# Road Safety Audit Report

Incorporating  
Stage 1 Completion of Preliminary design

## The Old Dairy Littlehampton

Visibility to the west

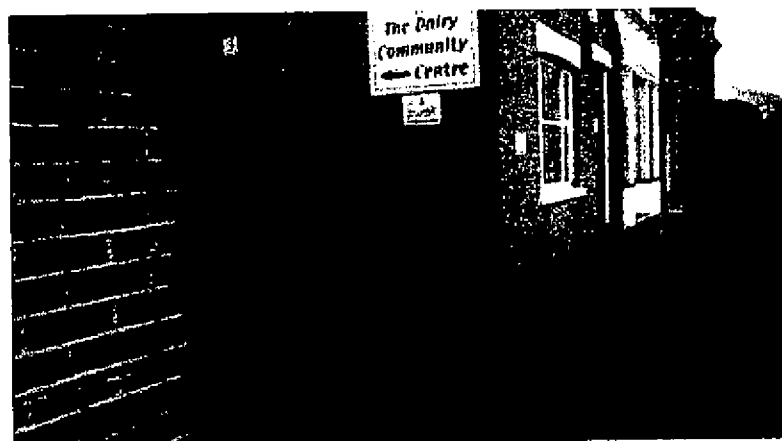
| dit<br>n No. | Audit Team Observation                                                                                                                                                                          | Audit Team Recommendation                                                         | Designer / Scheme Response                                                                                                                                                                                                                                                         |
|--------------|-------------------------------------------------------------------------------------------------------------------------------------------------------------------------------------------------|-----------------------------------------------------------------------------------|------------------------------------------------------------------------------------------------------------------------------------------------------------------------------------------------------------------------------------------------------------------------------------|
| .1           | <p><b>Problem</b>      <i>Restricted visibility</i></p> <p><b>Accident Type</b>    <i>Vehicle Collisions</i></p> <p><b>Location</b>        <i>Church Street west of the existing access</i></p> | <p>A speed survey should be undertaken and visibility increased if necessary.</p> | <p>The alignment of Church Street to the west and the presence of the on-street parking bays adjacent to the site result in vehicles not travelling along the channel line and therefore visibility is sufficient, ref: paragraphs 10.6.1 and 10.6.2 of Manual for Streets II.</p> |
